Descriptive Report to Accompany Hydrographic Survey H12085

Project OPR-P357-RA-FA-09
Southern Portion of Cook Inlet, Alaska
Eldred Passage and Sadie Cove
Scale 1:10,000
August – September 2009
NOAA Ship *Rainier* (s221)
Chief of Party: Captain Donald W. Haines, NOAA

Revisions and Corrections Compiled During Office Processing and Certification

Figure 2: IHO Uncertainty – failing notes depicted in red.

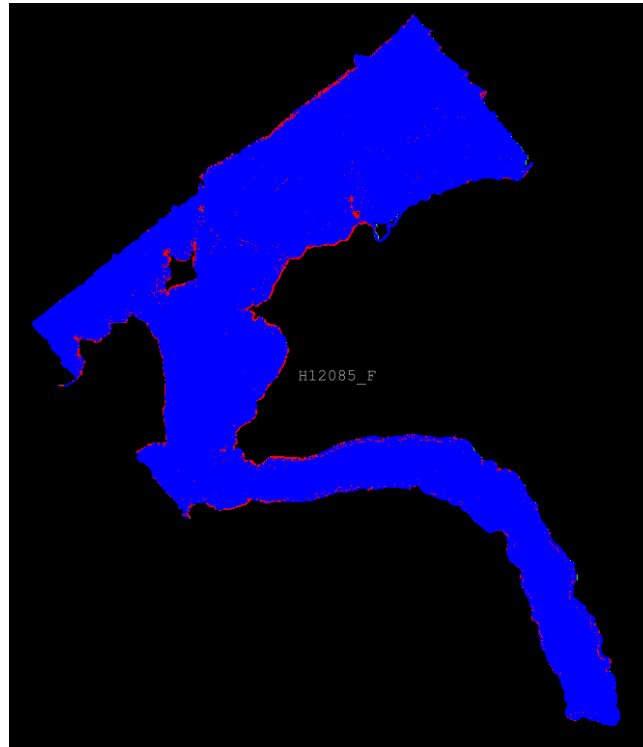
IHO uncertainty layer, with failing nodes in red. Edges of the survey and areas surveyed inshore using 1101 (RA-1) with a tilted 8125 multibeam were the most common instances of failing nodes; refer to *OPR-P357-RA-FA-09 DAPR* for specifics. Figure 3 depicts the surface data analysis, showing that 96.74% of nodes exceed IHO error tolerance requirements.²

² No soundings from red areas were selected for charting. There was nothing navigationally significant in the “red” areas.

Figure 4: Vessel 1101, Line 000_1945, DN226 Position Offset.

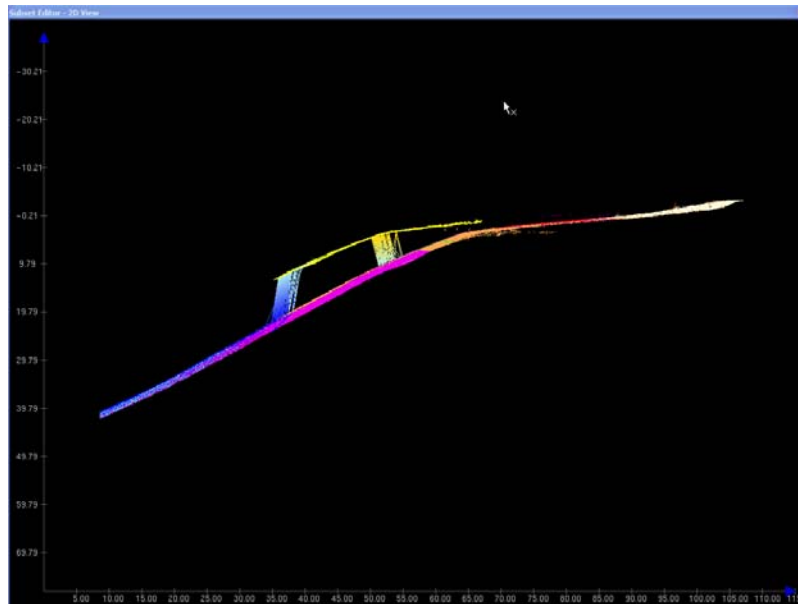
There were noticeable horizontal position offsets seen in Vessel 1101 (RA-1) data in inshore areas. This is most likely due to poor GPS signal quality and multipath error when adjacent to steep cliffs. Line 000_1945 DN226, illustrated in Figure 4, shows the maximum observed 10 meter offset, which exceeds IHO uncertainty specifications. Due to the high density of the data, the accurate depth was evident in the subsets despite the offset. SBET files were created in POSPac from GPS corrector stations in the area in an attempt to mitigate the positioning offsets. Although these correctors improved the horizontal positioning to within IHO specifications for most areas with only minor offsets evident, significant offsets still existed in data collected by vessel 1101 on DN 227 line number 000_1825. When errors exceeded IHO uncertainty specification, data were rejected manually to ensure the BASE surface honored the appropriate depth.⁵ Lines with applied SBETs include vessel 1101 DN 224 line 000_2030, vessel 1101 DN 226 line 000_1945, vessel 1101 DN 227 line 000_1825, and vessel 2803 DN 233 line 000_2301.

⁵ The data is adequate to supersede charted data in the common area despite the POS errors.

Figure 5: Sound velocity artifacts in Neptune Bay at approximately 59°33'28"N 151°23'00"W.

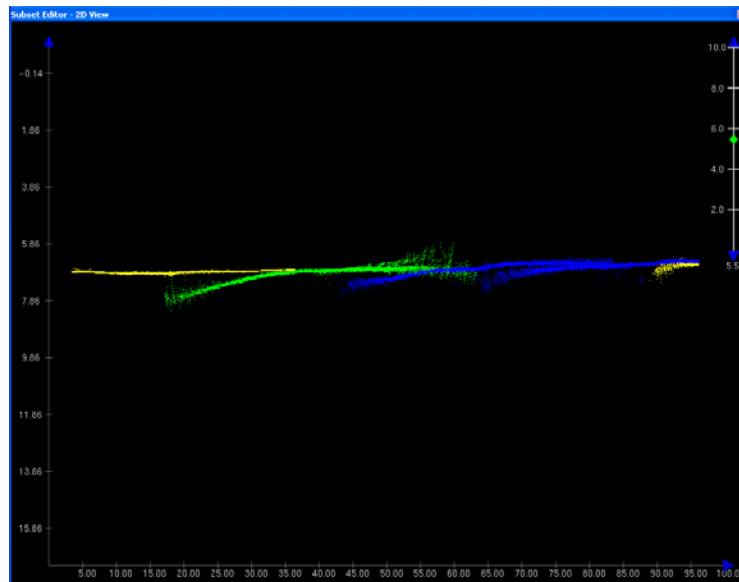
Due to freshwater runoff and the effects of tidal currents a sharp demarcation of water masses was often observed in the field. This proved to be problematic in the acquisition and application of sound velocity correctors. Despite the best efforts of the Hydrographer to conduct sufficient sound velocity casts distributed both spatially and temporally, sound velocity errors were still noticeable in several regions. After correction for sound velocity in

CARIS, some lines still exhibited the characteristic "smiles" and "frowns" indicative of inaccurate sound velocity corrections. To compensate, the Hydrographer, where possible, rejected soundings obviously in error on the outer beams.⁶ An example of sound velocity errors seen in the data is depicted in figure 5.

⁶ The data is adequate to supersede charted data in the common area despite the SV errors.

Figure 8: South Sadie Cove at 59°28'35.28"N 151°21'29.90"W. 8 meter horizontal gap in 2m curve indicated by arrow. 2 meter curve indicated between the red and purple depth ranges.

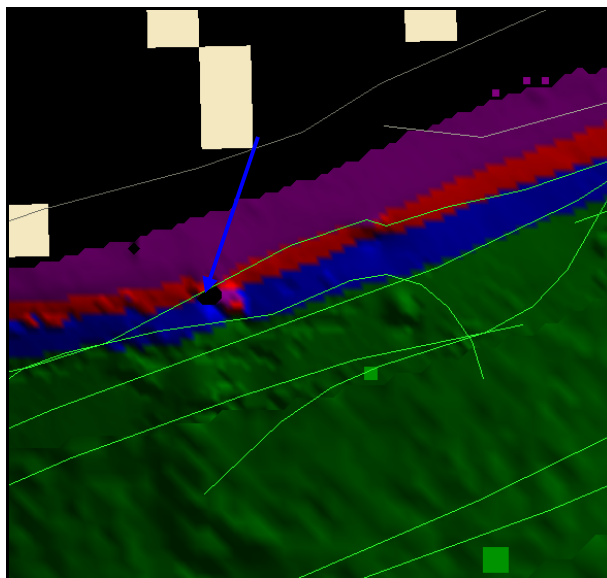
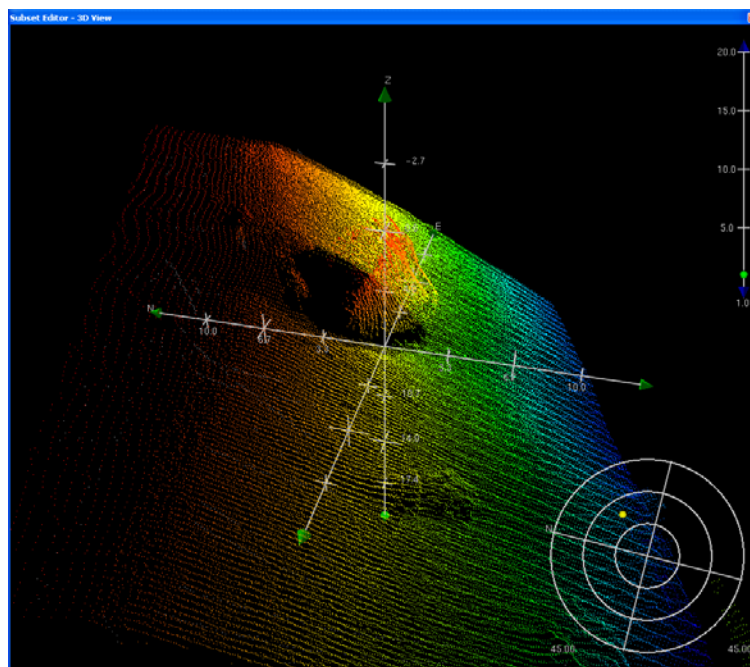
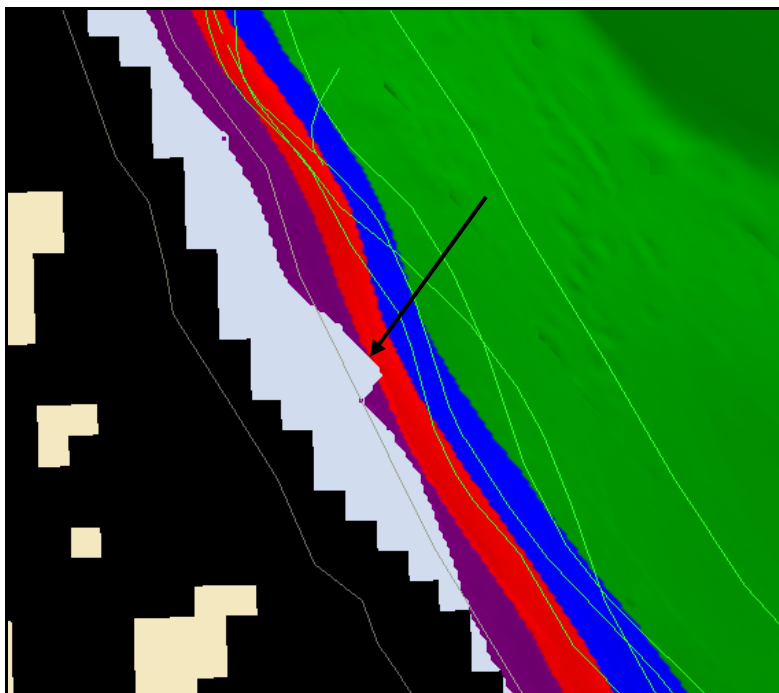
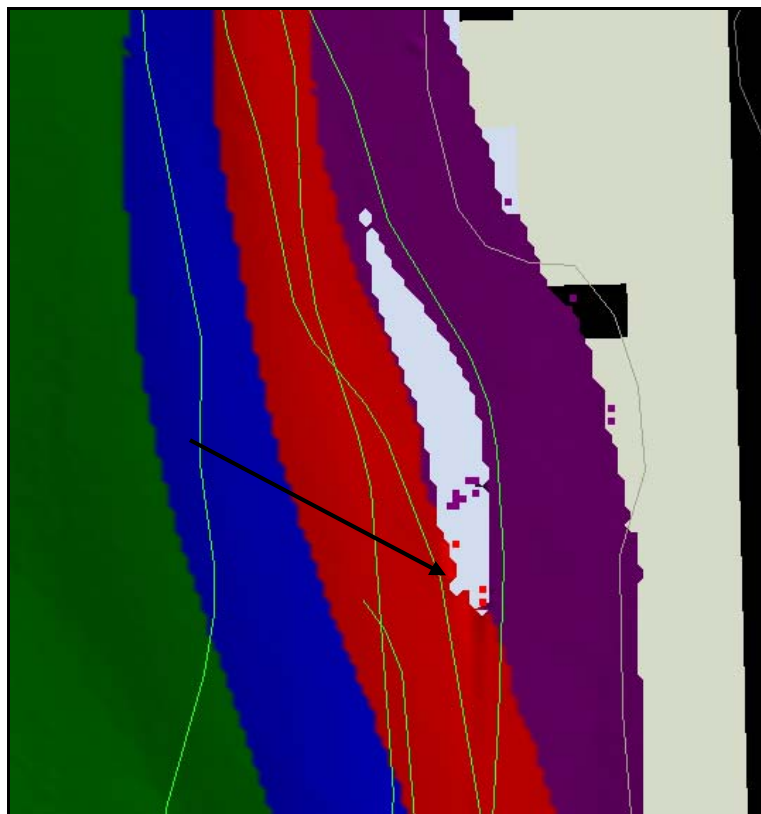
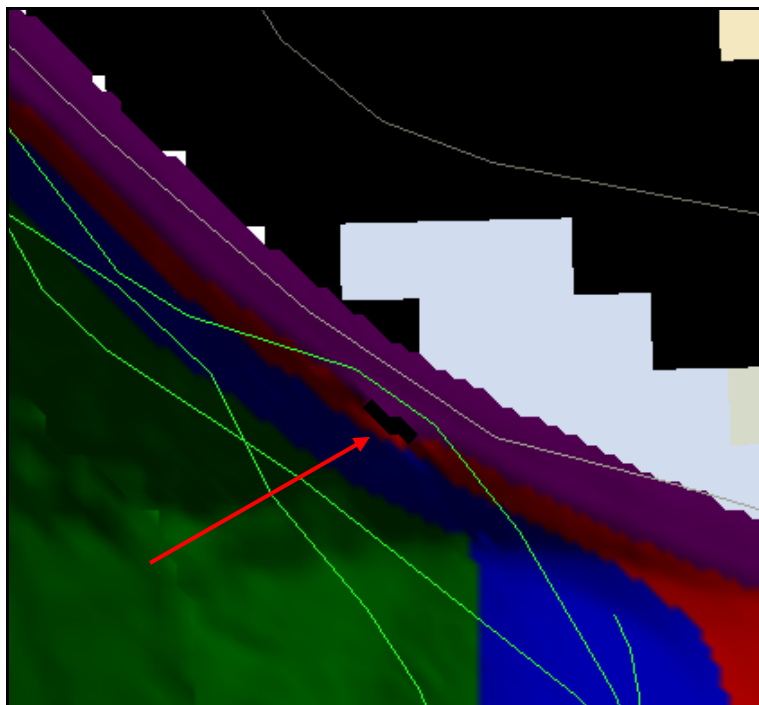
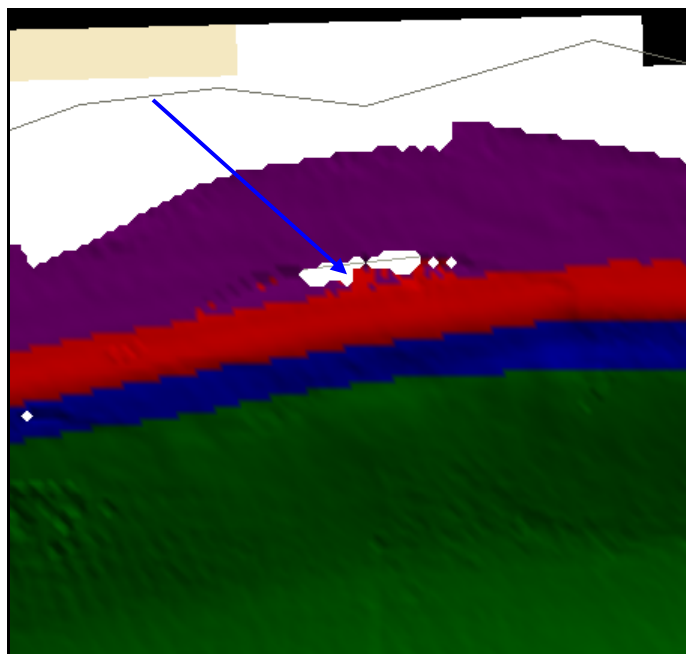
Due to lower water levels on some days of acquisition in Sadie Cove, complete coverage, as specified in the Project Instructions was not attained to define the entire 2 meter curve. There were four instances of gaps in coverage in Sadie Cove, as depicted in figures 8-11.⁷

⁷ Concur. Data were examined to ensure that significant features were unlikely inside the holidays.

Figure 14: AWOIS item 53705 with survey outline overlaid in red (circle indicated AWOIS Radius)

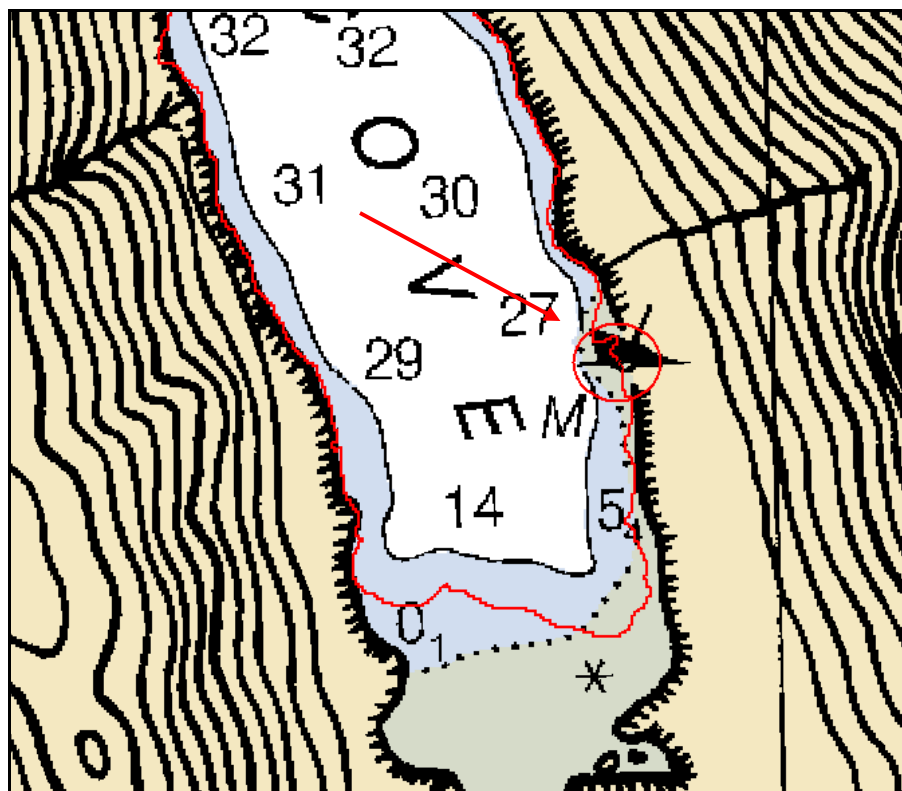
One (1) AWOIS item was located within the survey limits of H12085. This item was assigned for full investigation. The assigned item is currently depicted as a visible wreck on the chart, as depicted below in figure 14. Upon shoreline investigation scattered remnants of the wreck were visible on shore near the mean high water (MHW) line; however the debris was unidentifiable and navigationally insignificant. The Hydrographer recommends removal of the “Visible Wreck” symbol from the chart.¹⁵ Description and pictures of the AWOIS item investigation are included in the Survey Feature Report in Appendix II.

¹⁵ Concur with the hydrographers recommendations to remove the charted AWOIS item #53705. In addition it is recommended to remove the item from the AWOIS database.

Figure 15: Overhead power cable at the entrance of Sadie Cove

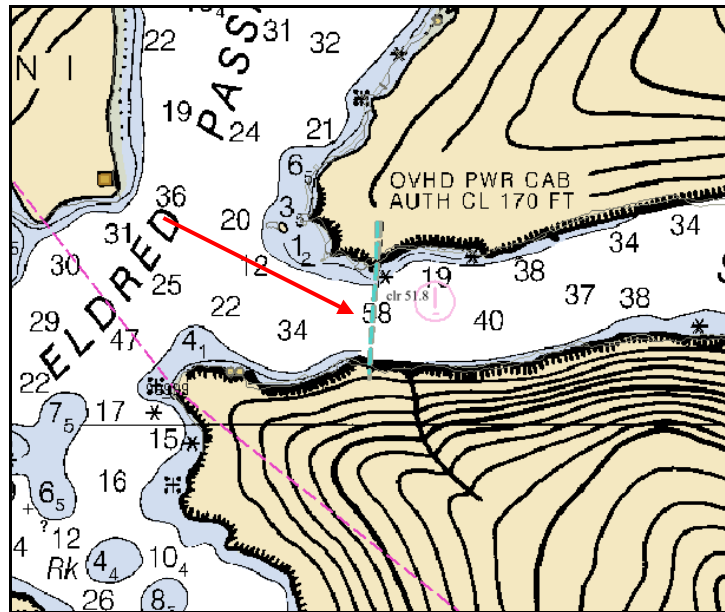
There is one overhead feature in H12085, a power line over the entrance of Sadie Cove, depicted below in figure 15. The vertical clearance as provided in the composite source file

listed 51.8 meters, which corresponds to the charted 170 foot (51.8 meters) clearance above Mean High Water. The position and height of the feature was visually checked in the field and does not impede navigation in the area, though no direct measurement was conducted.²⁰

²⁰ Chart features as depicted in the HCell.

Figure 16: H12085 Cable area

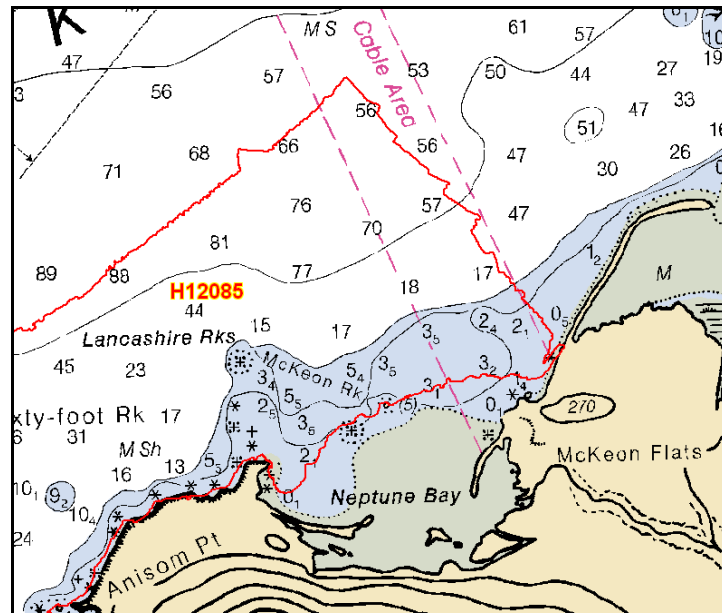
There is one charted cable area within the survey limits of H12085, as depicted below in Figure 16. No visible indication of cables was evident in the MBES data in the charted cable area extending northwest from the shore of McKeon Flats. The Hydrographer recommends retaining the cable areas as charted.²¹

²¹ Concur. A blue note was added to the HCell to retain cable area.
